工程指示 / 要求簡箋(E.I.)

工程指示編號：EI / 6187 23

工程名稱：將軍澳日出康城 11

工程項目：顧問上廠報告 (31/3-5/5) 精華版加完整版

Photo 10

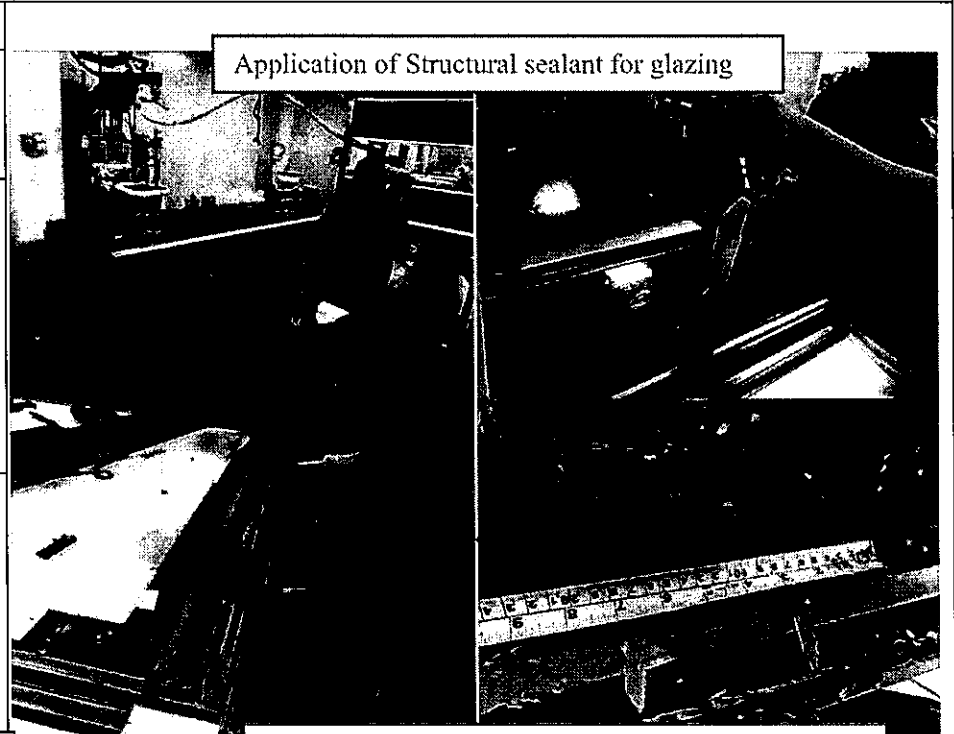
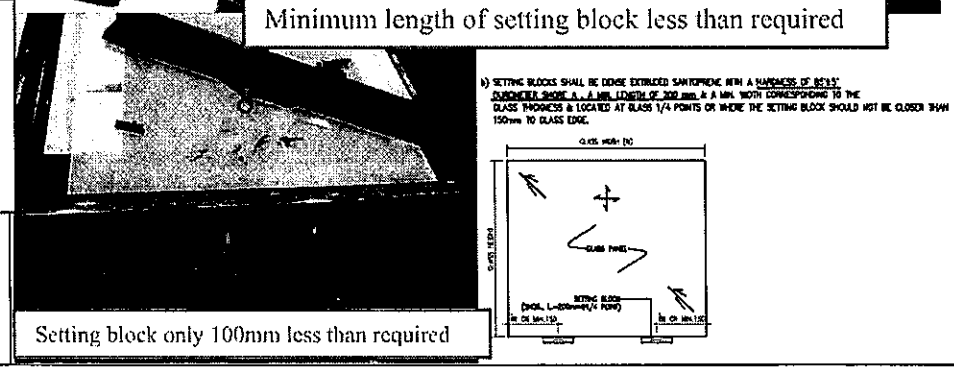
Action:
- MIDI is reminded to carry out the remedial works prior products delivery and to improve workmanship for future works

#1:
黑膠墊最少要長 200mm, 補相

Photo 13

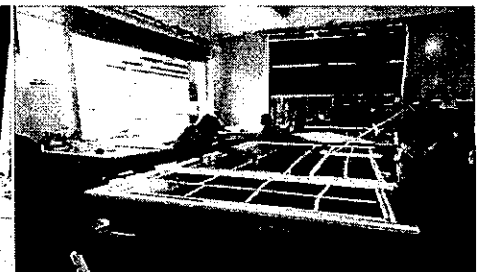
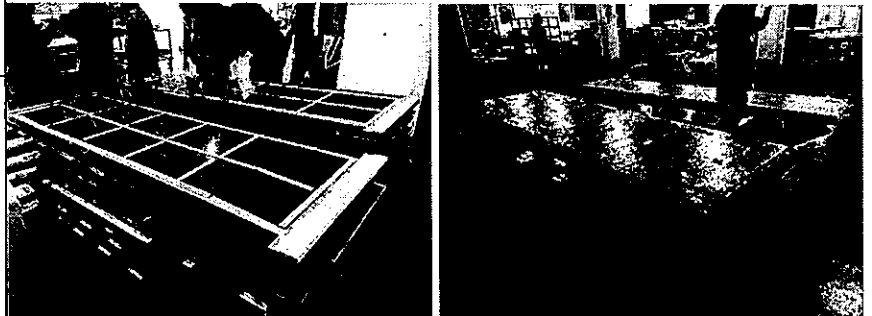
Missing wooden block for protection of gasket

#3: 對膠條保護再做好一點，飛機帶跟木壓到膠條的位置做點保護，影相。

Photo 10

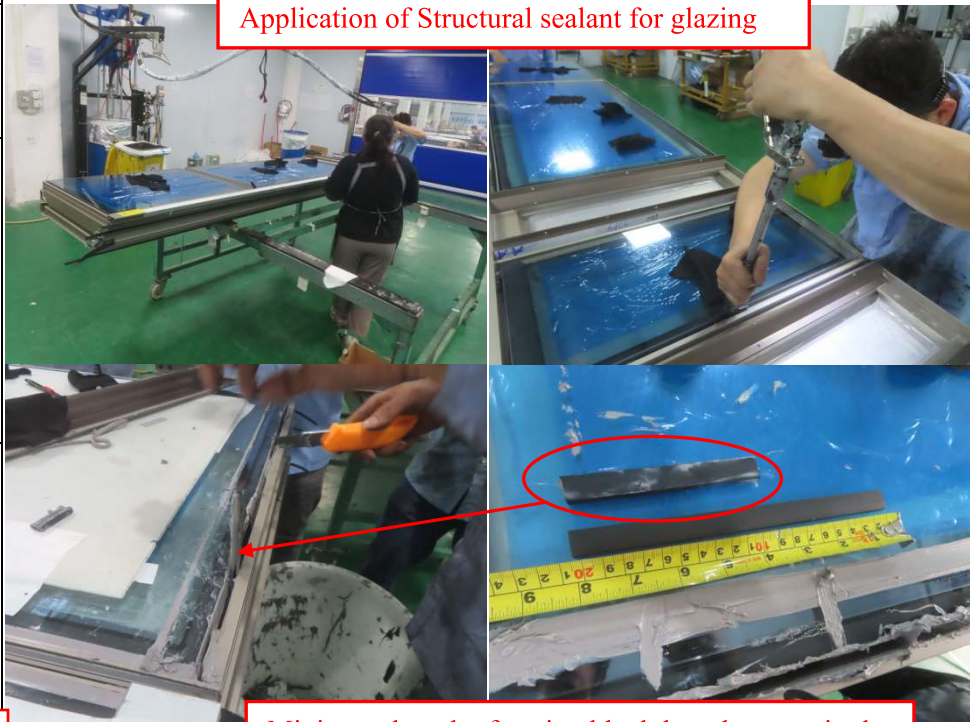
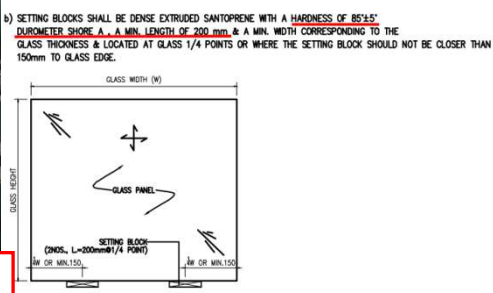
Minimum length of setting block less than required

Setting block only 100mm less than required

#1:
黑膠墊最少要長 200mm, 補相

Photo 11

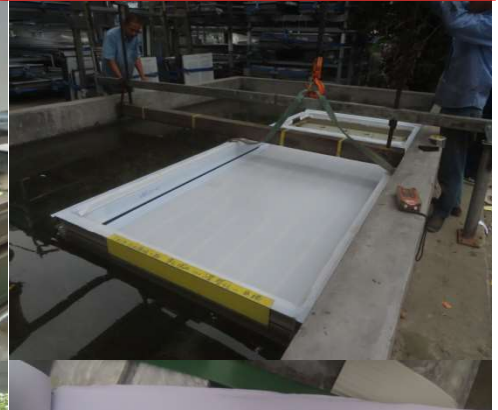
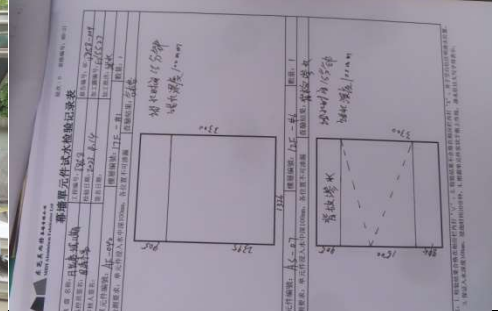
Leakage was found during water flooding test

Possible source of water leakage

#2:
單元件12/F_T3B-CW4_AS-07
入水, 影合格試水紀錄照片

Photo 8

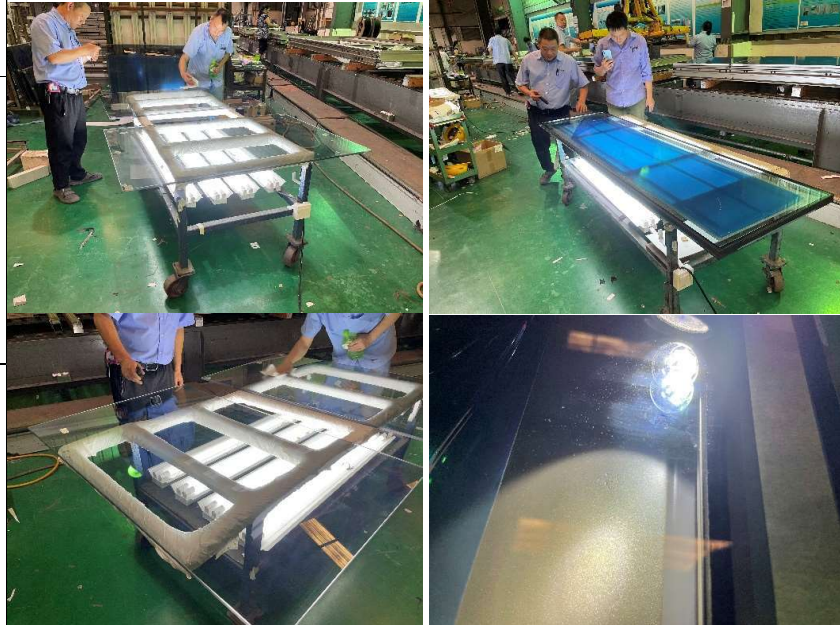
Glue workshop is not a closed space, resulting in more dust and high temperature

#4: 影一張唧膠部的相是密封和溫度適中的空間。
